DO NOT ADJUST THE DIMENSION FROM THE DRAWING			
NAME	SIGNATURE	DATE	
DRAWN BY	M.KARADELI	15.10.98	
CHECKED	M.KARADELI	15.10.98	
APPROVED	C.GÜLERYÜZ	15.10.98	
SCALE	Item Name:		
	19.5x7.50

DRAWING NO
750192

Fig. 19.5x7.50 (Specification of 19.5x7.50) and L.P. 750192

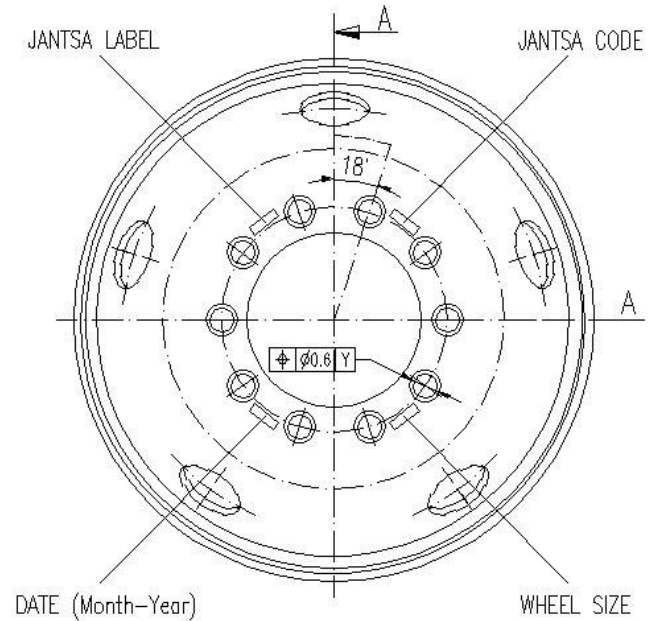
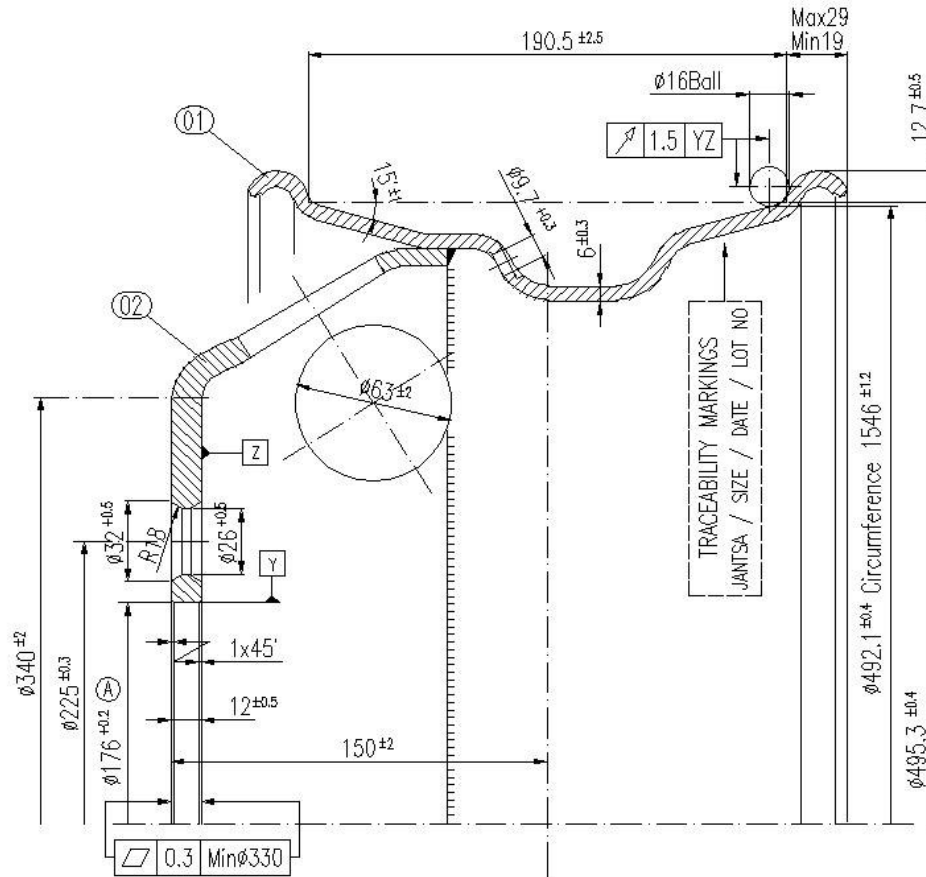
LETTER	DESCRIPTION	REVISION	DATE	REV.NO
(A)	Bore hole diameter tolerance is changed. Before +1 Now +0.2	Drawing is changed.	09.09.04	1
